TO: City of Hudson Planning Commission for November 9, 2015 Meeting

SUBJECT: Site Plan Review for 7041 Darrow Road
American Fireworks – Warehouse Facility

PC Case No: 2015-28

AMERICAN FIREWORKS

OVERALL
 PLAN

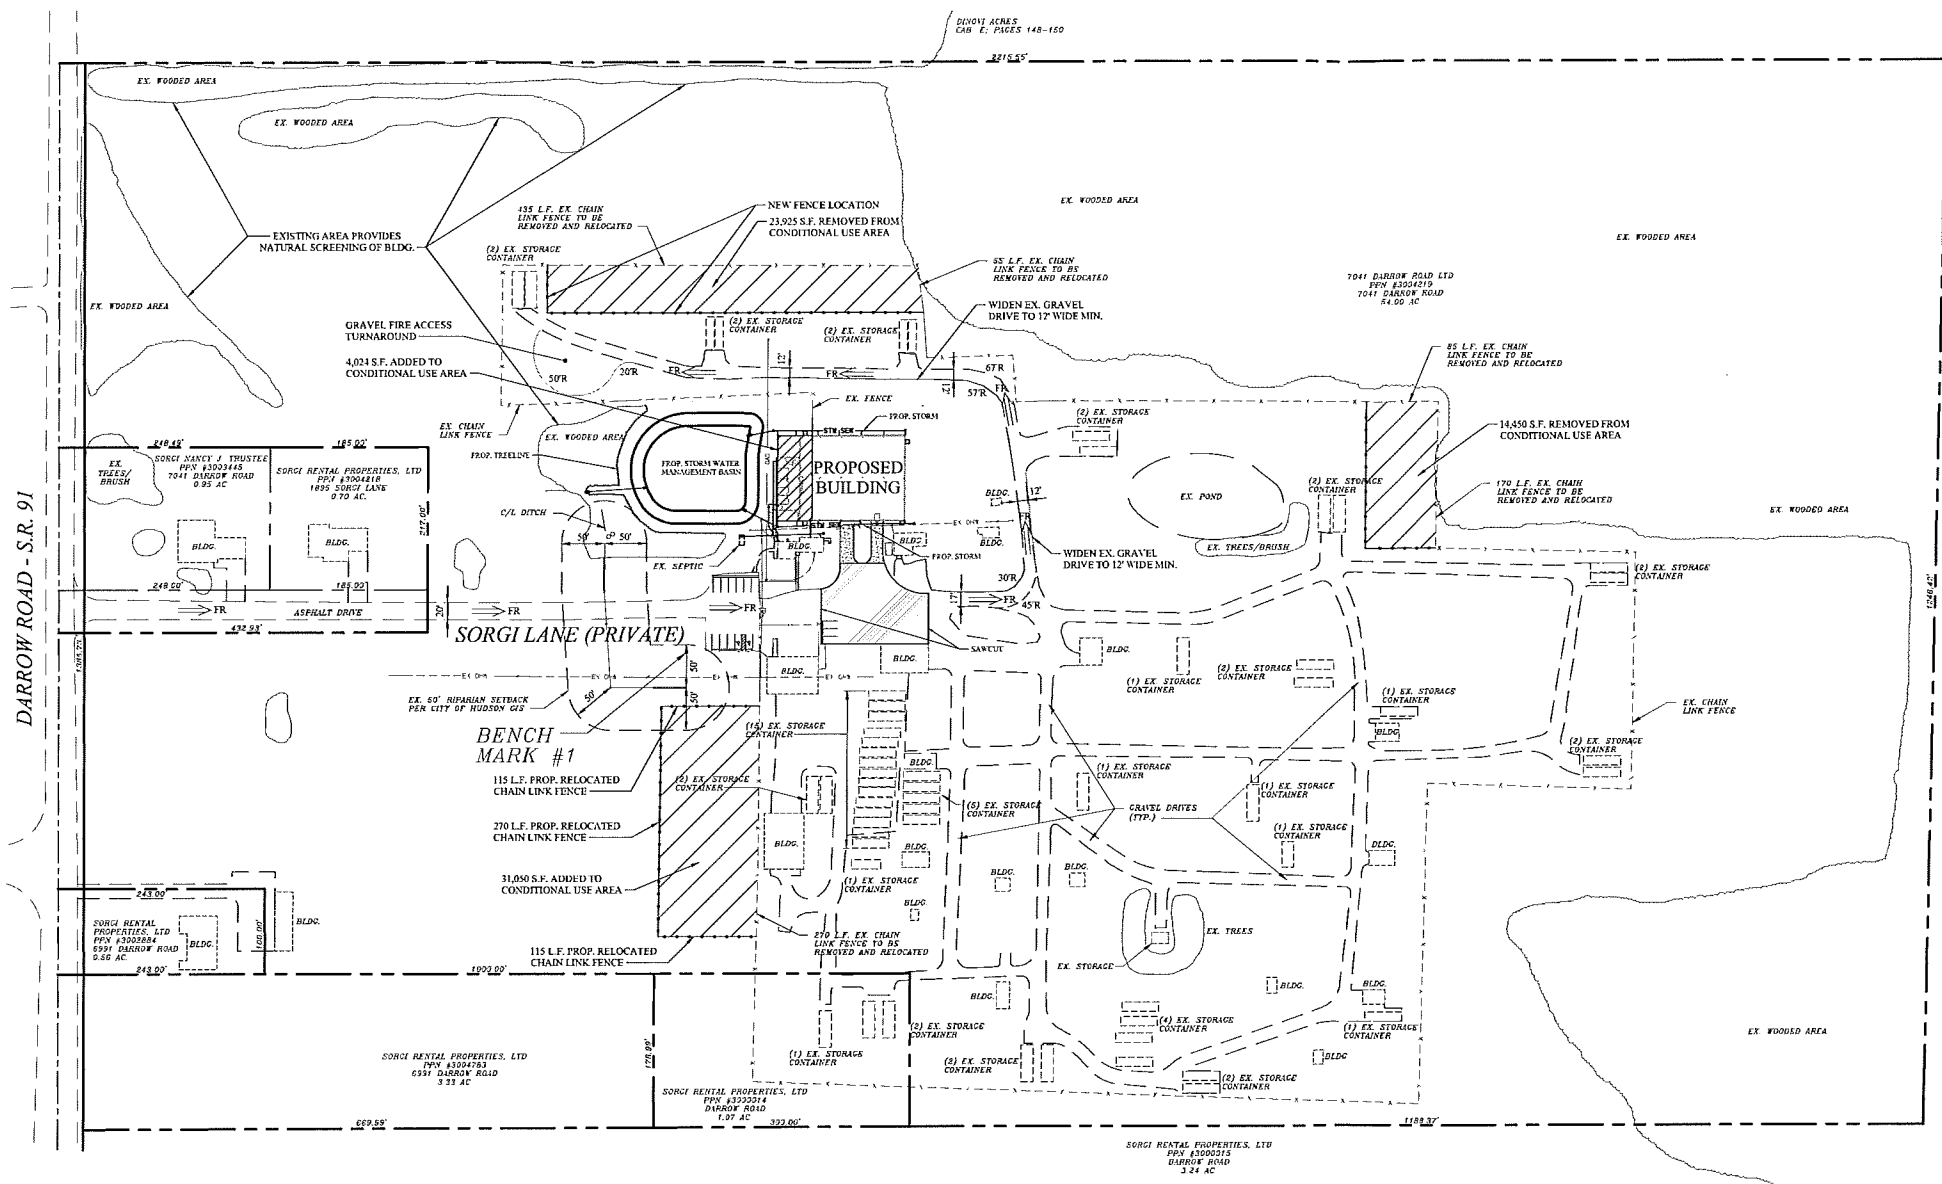
Staff notes some revisions have been proposed to the dimensions of the fence enclosure. Two areas have been reduced in size adjacent to the north and east portions of the enclosure. Additionally, a portion of the proposed building increases the enclosure area as does a fencing expansion at the western portion of the site. The proposed reconfiguration is acceptable as the net result is a decrease in the enclosed area by 3,301 square feet. The plans should be revised to label the total amount of area within the fence enclosure.

The plans indicate the removal of two sheds from the property which are adjacent to the development site. The property owner has stated three additional small sheds will be removed from the site as well as several inoperable vehicles/equipment located northeast of the development site. These will need to be labeled on the site plan.

Emergency Access: All portions of the exterior wall of any structure must be located within 150 feet of a public street or approved fire access road. Staff notes the existing gravel drive located along the east and north sides of the building is proposed to serve as a fire access road.

1. Provide the existing and proposed total square footage within the fence enclosure.
2. Submit a landscape plan providing Bufferyard D (25feet, substantial) to the adjacent single family residential development to the north.
3. Label the existing buildings and equipment which are proposed for removal as part of the project.
4. The City Engineer must approve the final plans.
5. The applicant shall install silt fencing and/or polypropylene fencing to mark and protect the approved limits of disturbance, which shall be maintained by the applicant.
6. Satisfaction of the above conditions prior to scheduling of a preconstruction meeting with City Officials and no clearing or construction of any kind shall commence prior to the issuance of a Zoning Certificate.

SITE PLAN

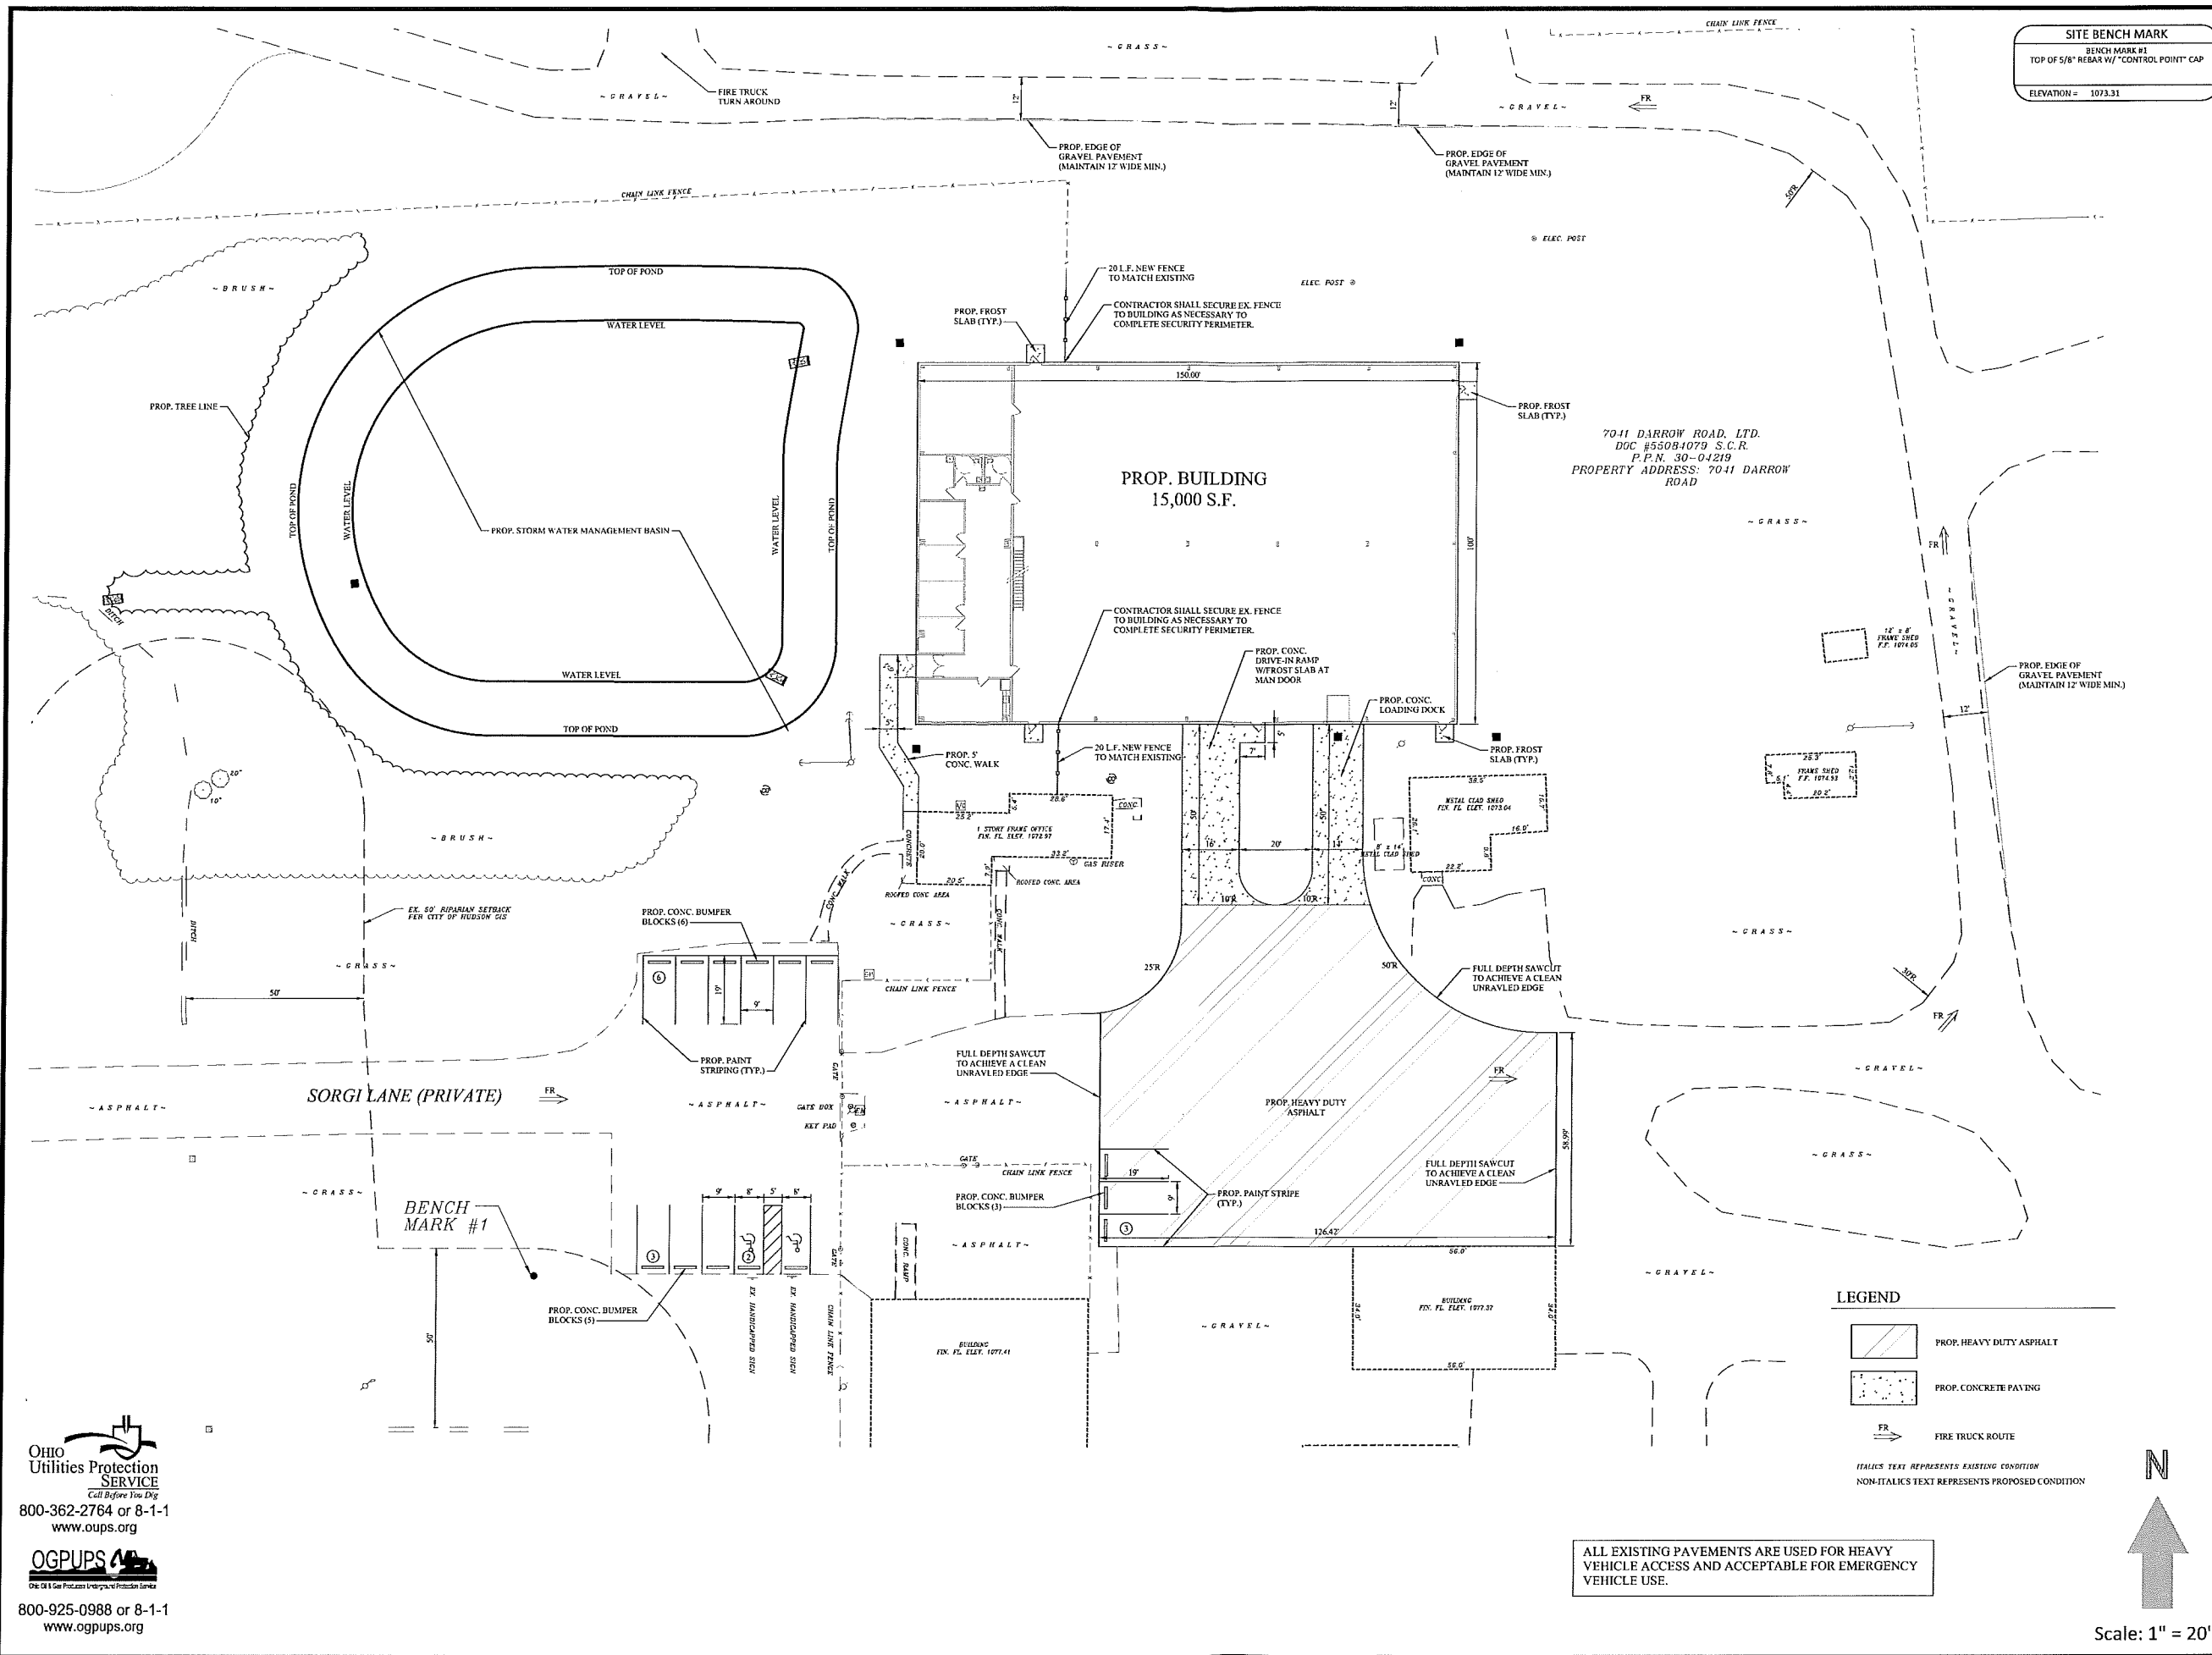
The plan submittal must depict the applicable 20 foot inside, 40 foot outside turning radiuses required for emergency vehicles.

5. Indicate a minimum fire access road width of 12 feet and revise the layout along the north side of the proposed building with a revised turn around design, allowing the existing storage containers to remain in place rather than relocating them further to the north.

6. Depict the applicable 20 foot inside, 40 foot outside turning radiuses required for emergency vehicles.
7. Revise the stormwater management design to significantly increase the preservation of the natural area to the west of the proposed building to lessen any environmental impacts and to enhance the screening of the building from Darrow Road.
